**MAINTENANCE
INFORMATION**

MI13-06

DATE :	MAY 2013	SECTION :05-Cooling System
SUBJECT :	HOSE CLAMP FOR COOLING SYSTEM CONNECTION

Figure 1

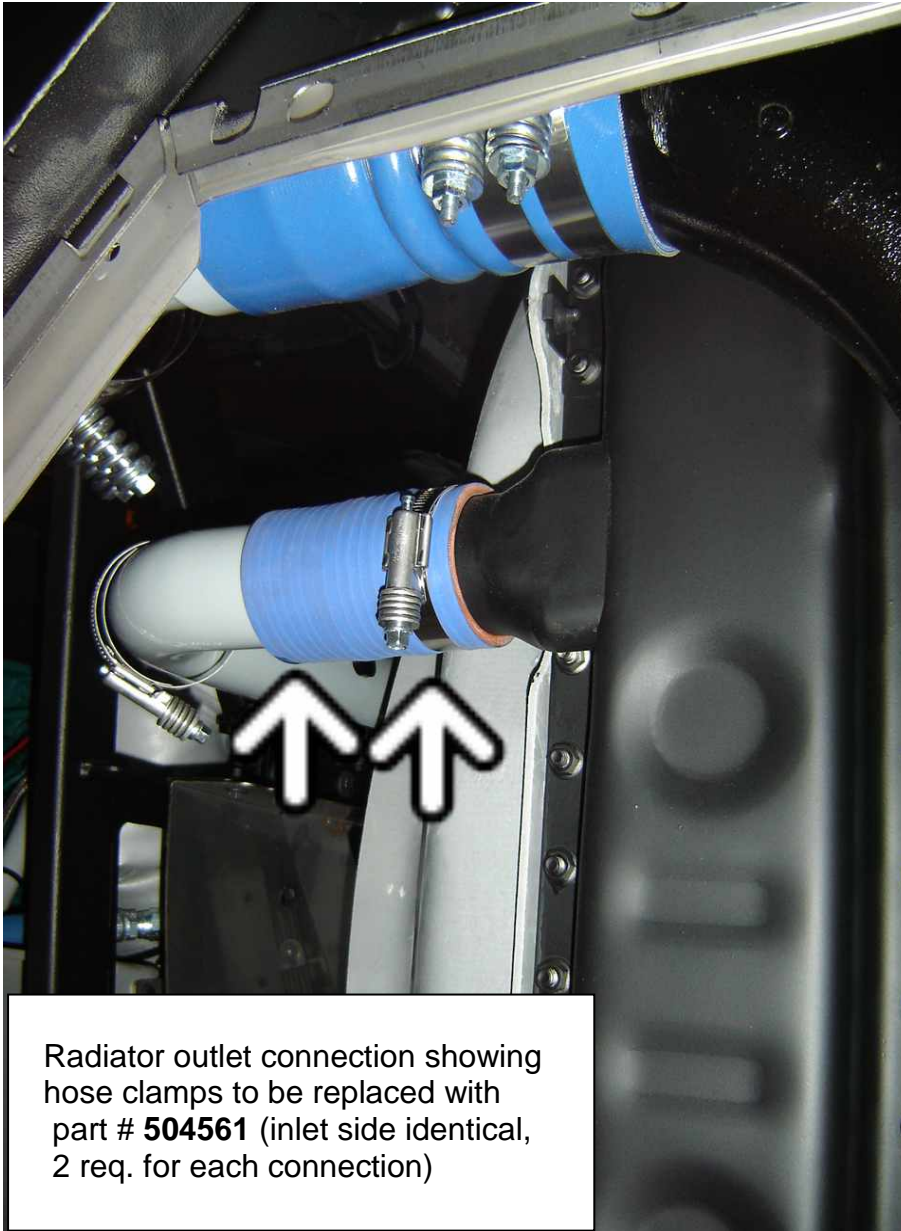
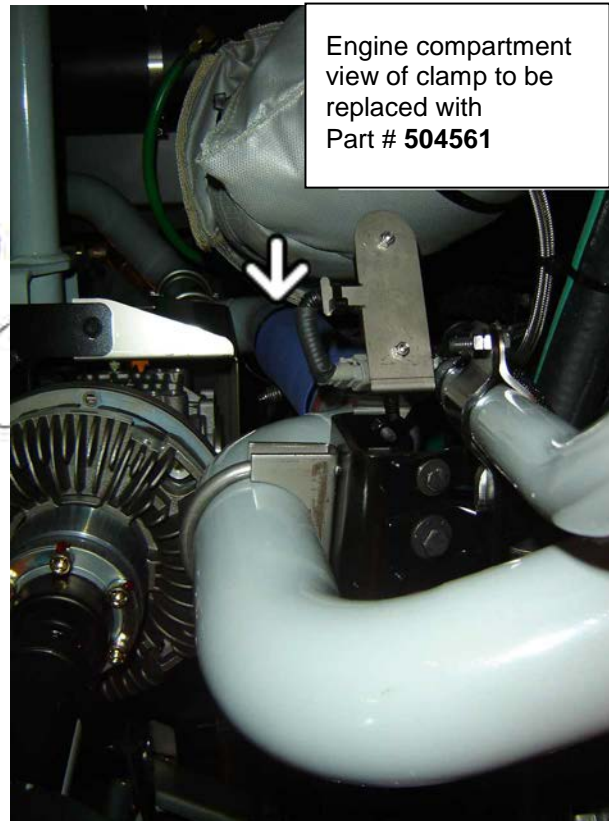
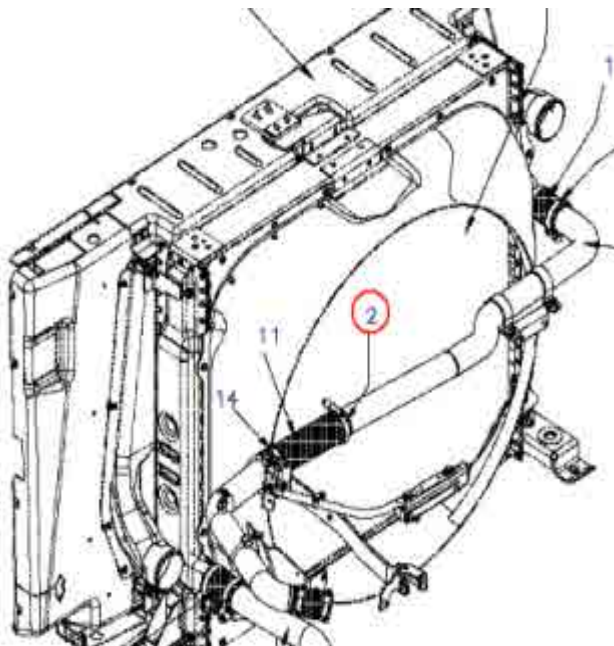
- 7- Replace the four (4) hose clamps on the blue flexible hoses located at the radiator inlet and outlet connection with four (4) new hose clamps (part # **504561**).

8- On the radiator connecting hose near the turbocharger, replace the hose clamp nearest to the radiator outlet (number 2 on figure 1) with a new hose clamp (part # **504561**).
